NRC-00-059

Docket 50-305
Operating License DPR-43
Kewaunee Nuclear Power Plant
Proposed Technical Specification Amendment Request PA #167 Spent Fuel Storage – Response to Additional Information

Radiological Responses

Requests For Additional Information

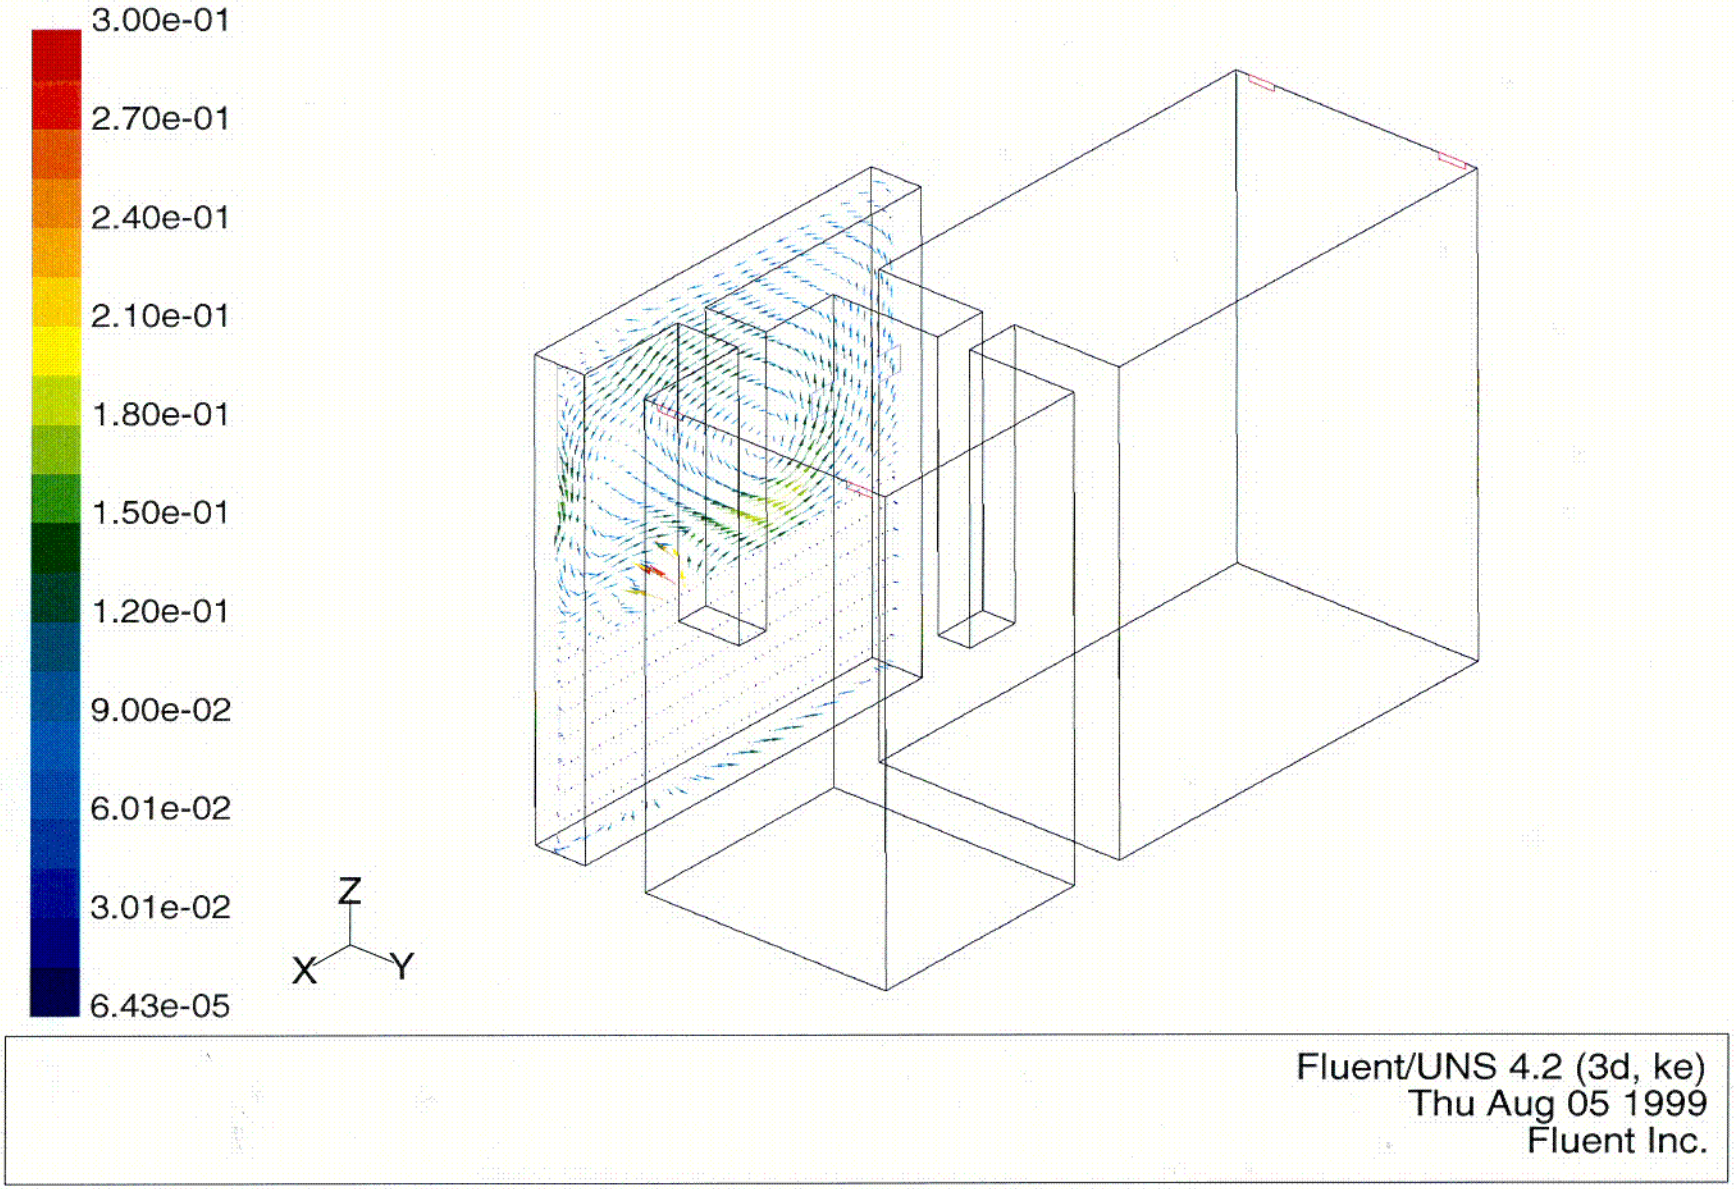
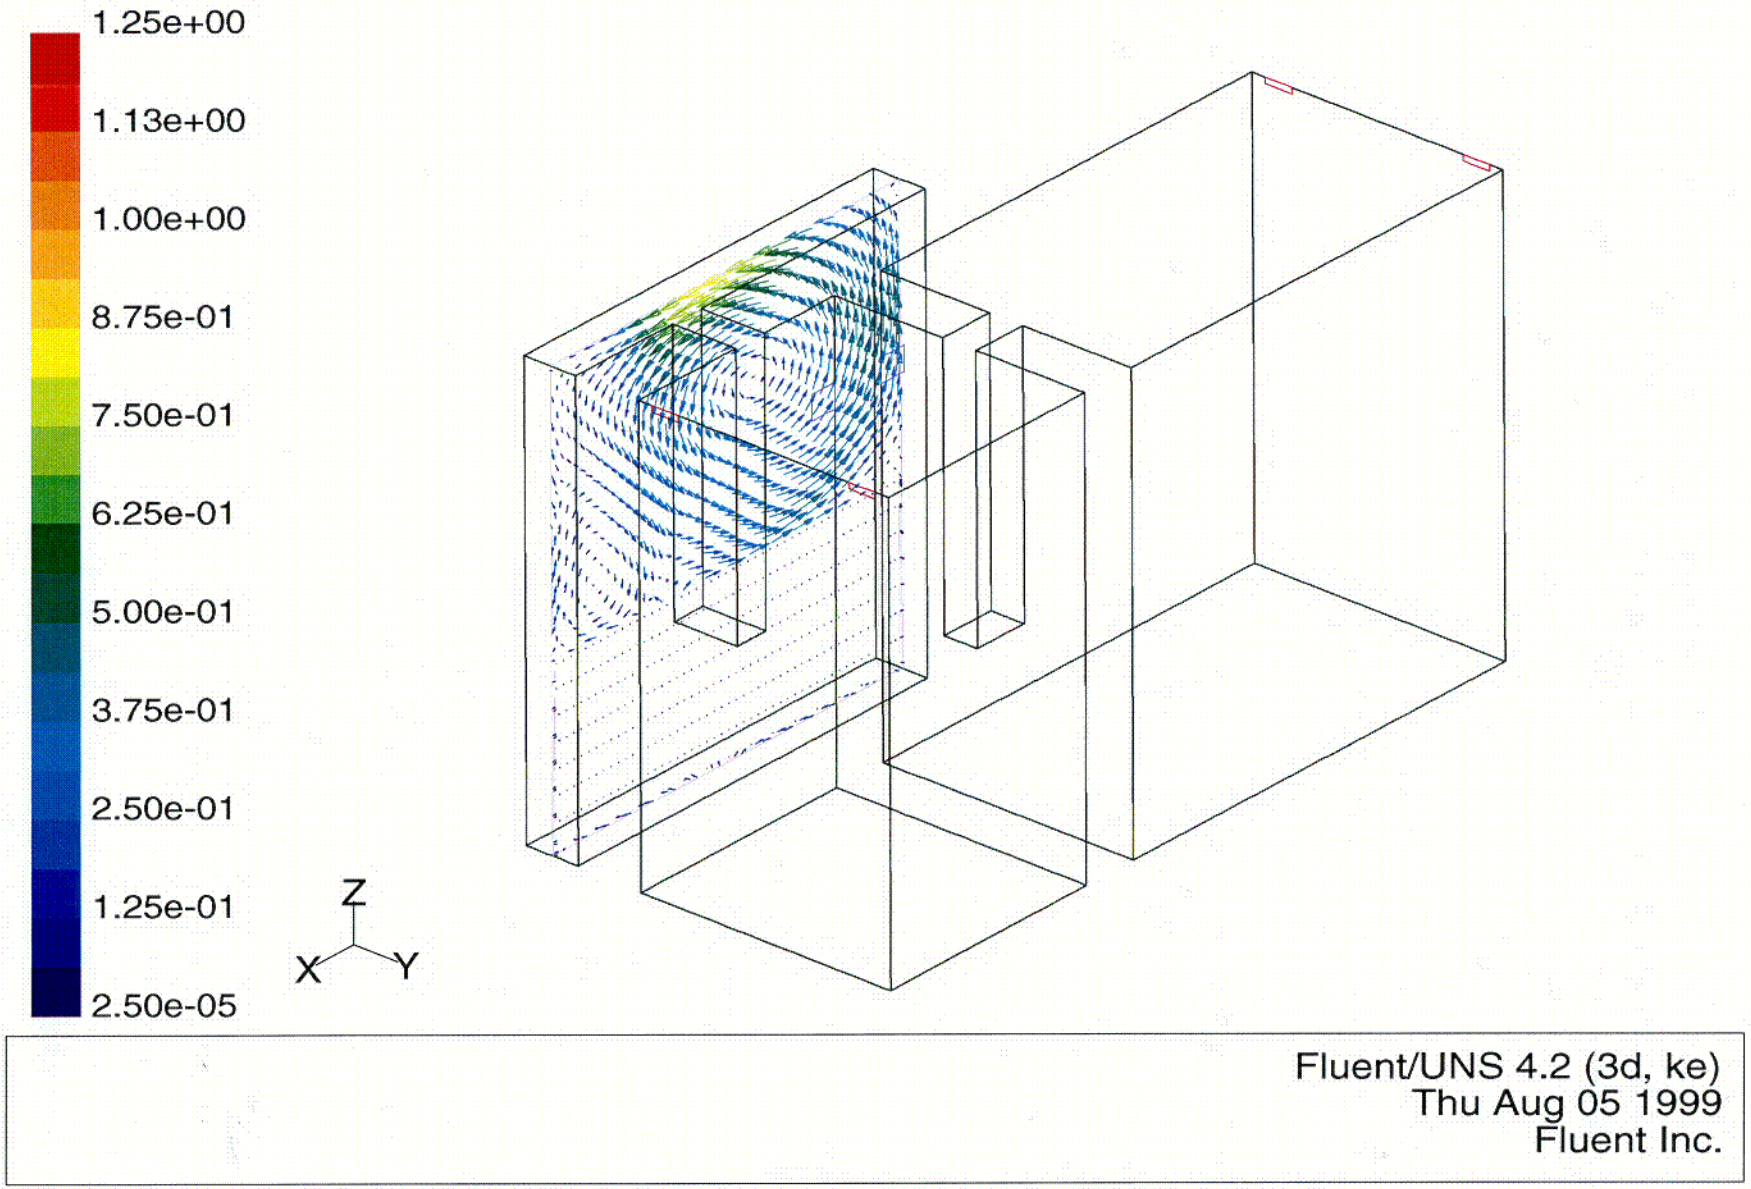
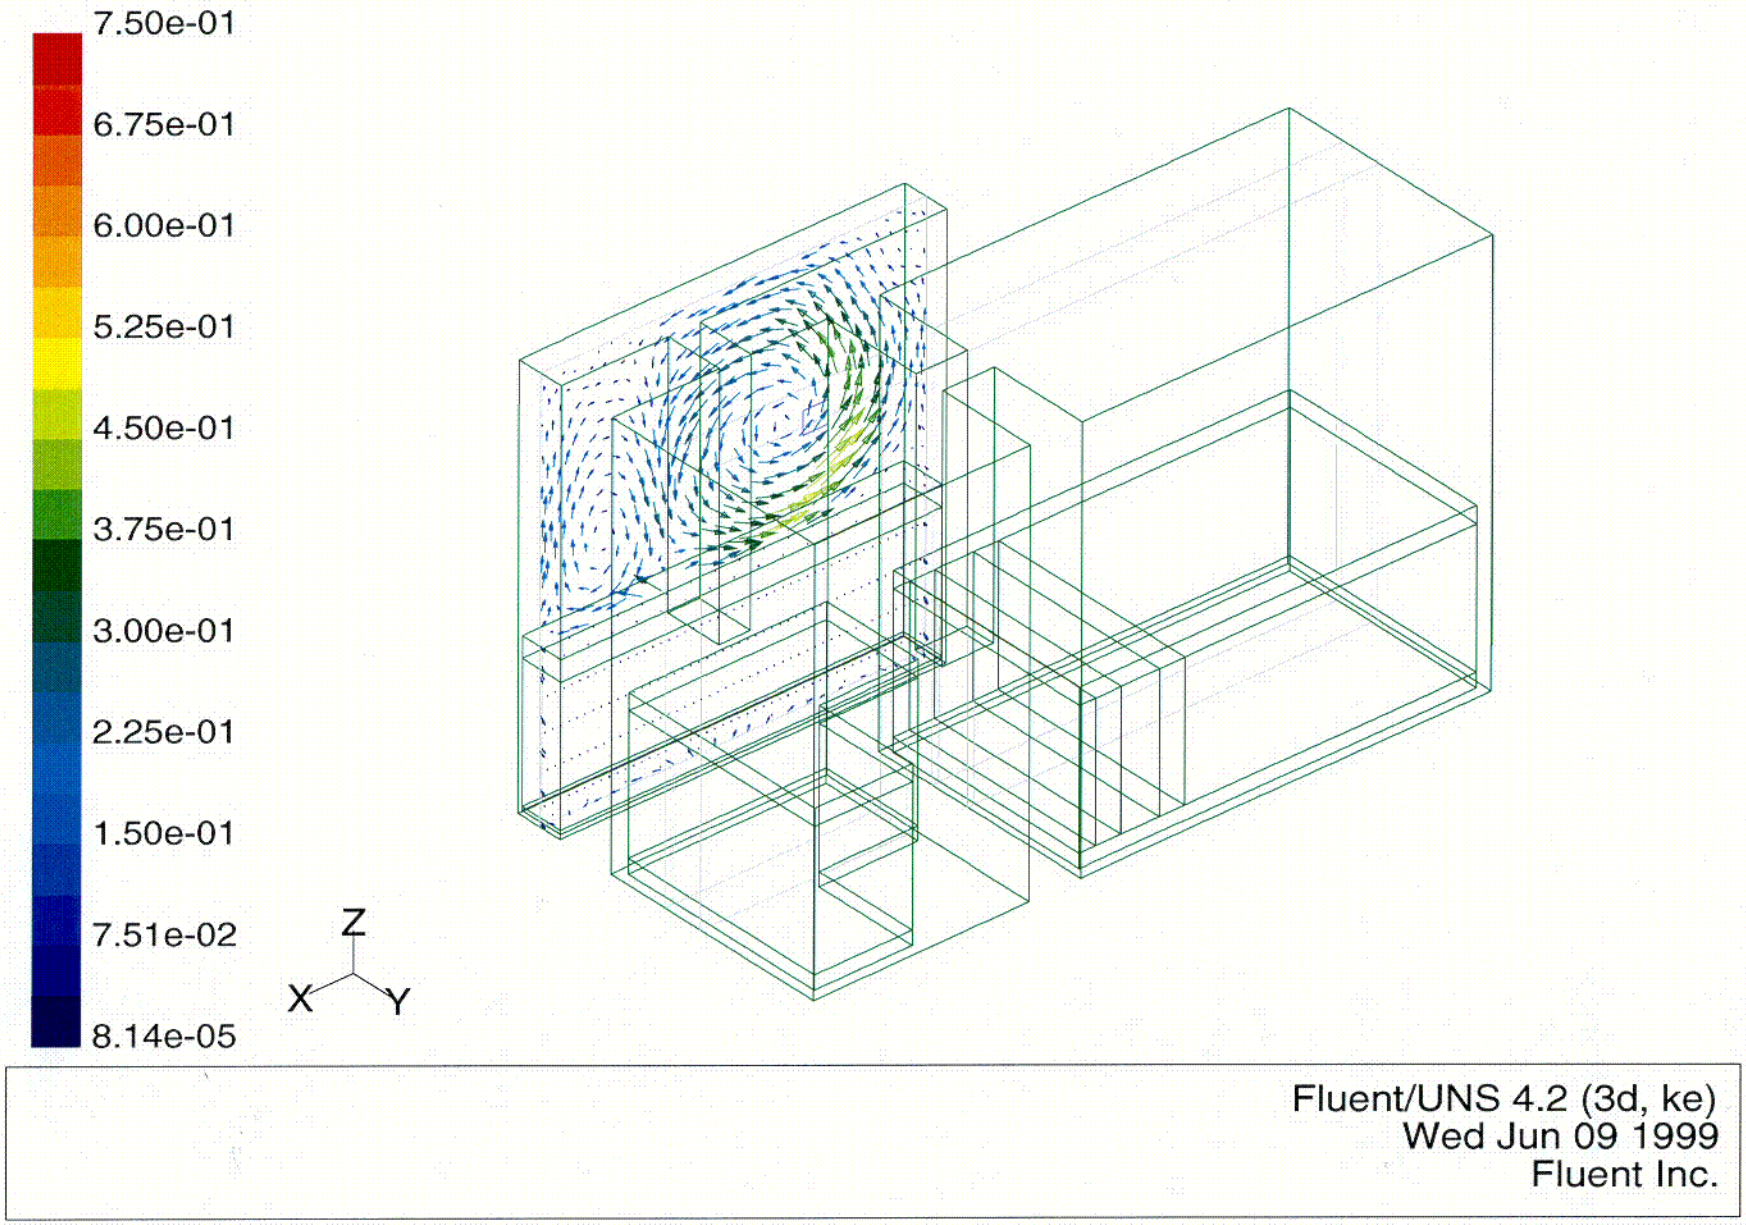
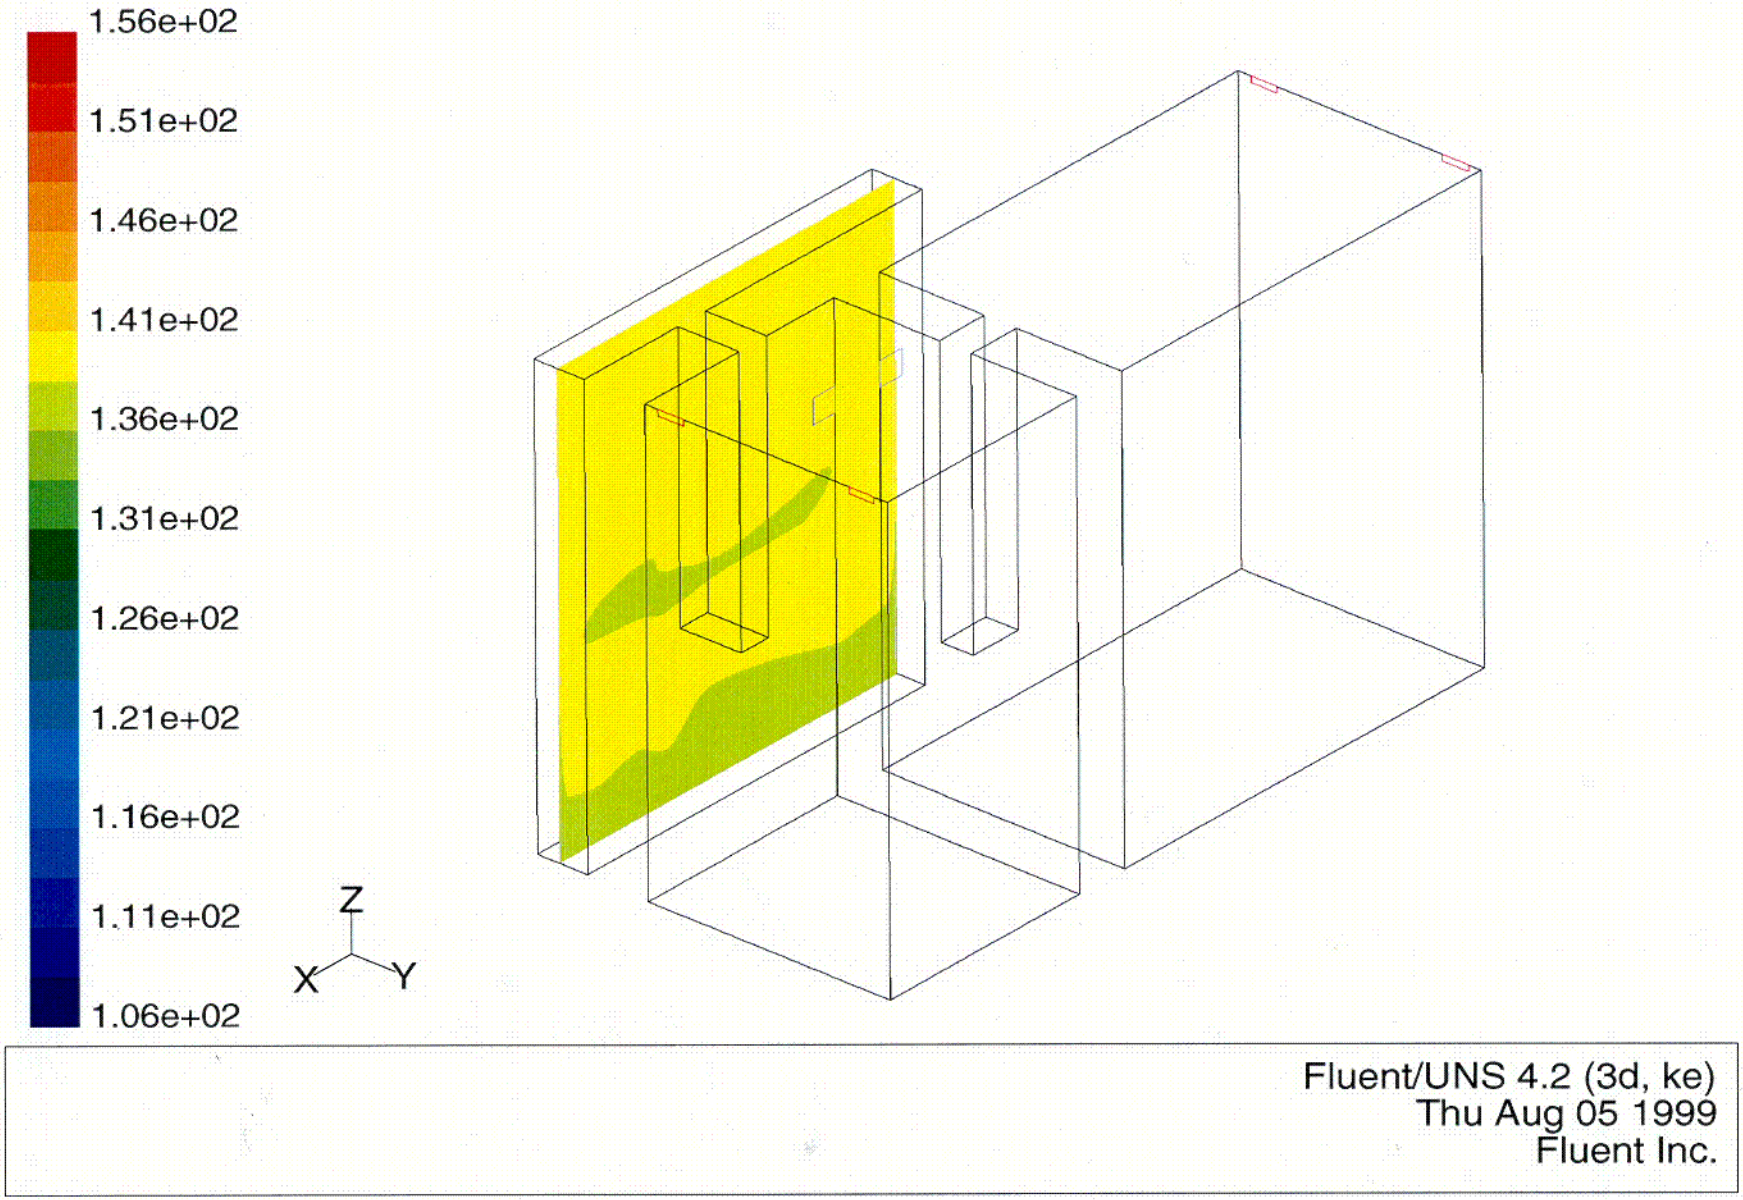
The new storage section in the north transfer canal is connected to the main pool through a relatively narrow slot. This new storage area does not have direct cooling. Although this new storage area is cooled by natural convection through this slot (Page 5-18, Attachment 5), it is not obvious that this cooling is adequate. Please provide the temperature and velocity distributions in the new storage section through the middle plane in the north-south direction (similar to that shown on Figure 5.8.2). Explain the mechanism how this section is cooled using the above temperature and velocity profiles. What is the estimated maximum temperature difference between this section and the pool bulk temperature? What are the dimensions (width and height) of the transfer slot? Are there any temperature monitors in the new storage section?

Figures 1, 2 and 3 present the velocity vectors in a vertical plane through the middle of the transfer canal racks for the partial core, full core and emergency full core discharges, respectively. Figures 4 through 6 present the corresponding temperature contours in the same plane.

Although not identical, the velocity vectors in Figures 1 through 3 all show a similar pattern; water from both ends of the new storage section flows toward the slot that connects the new storage section to the north spent fuel pool. The general pattern is that the heated water issuing from the top of the racks is swept horizontally across the top of the racks toward the north and south ends of the new storage section, where it rises toward the water surface and flows to the slot. This demonstrates that there is a vigorous, passive mechanism for moving heated water from the fuel assemblies in the new storage racks through the slot and into the north spent fuel pool, where it can be subsequently transferred to the SFPCS.

The temperature contours in Figures 4 through 6 demonstrate the efficiency of the above described water flow pattern on removing heat from the stored spent fuel assemblies. The contours indicate that there is little thermal stratification in the water of the new storage area, with temperature variations of approximately 5°F in all three scenarios. All scenarios have similar heat loads in the new storage area, so the similarity of the temperature gradients is not unexpected. The uniformity of the temperatures in the new storage area demonstrates that the heat generated in the stored fuel assemblies is not permitted to build-up large temperature gradients in the water, which is indicative of a vigorous exchange of water with the north spent fuel pool.

Figures 4 through 6 can also be examined to determine the difference between the new storage area temperatures and the pool bulk temperatures. The following table presents a comparison of the new storage area temperatures with the corresponding bulk pool temperatures.

An examination of the values in this table show that there is practically no difference between the temperatures in the new storage area and the corresponding bulk pool temperatures. This is not surprising, as the majority of the total discharged fuel decay heat is located in the existing spent fuel pools and not in the new storage area. The relatively small decay heat generation in the transfer canal ensures that a small temperature difference between the new storage area and the north pool generates sufficient buoyancy forces to transfer the heat from the new storage area to the north pool.

The slot that connects the new storage area to the north spent fuel pool is 2'-6" wide by 22'-11 1/4" high (to the as-modeled water depth). To simplify the geometric modeling of the slot, a slightly smaller height is used in the analysis model, with the bottom sill of the slot raised by 7 inches. This large opening (over 57 ft^2, modeled as over 55 ft^2) provides a low resistance flow path between the

new storage area and the north spent fuel pool. There will be no temperature monitors in the new storage area.
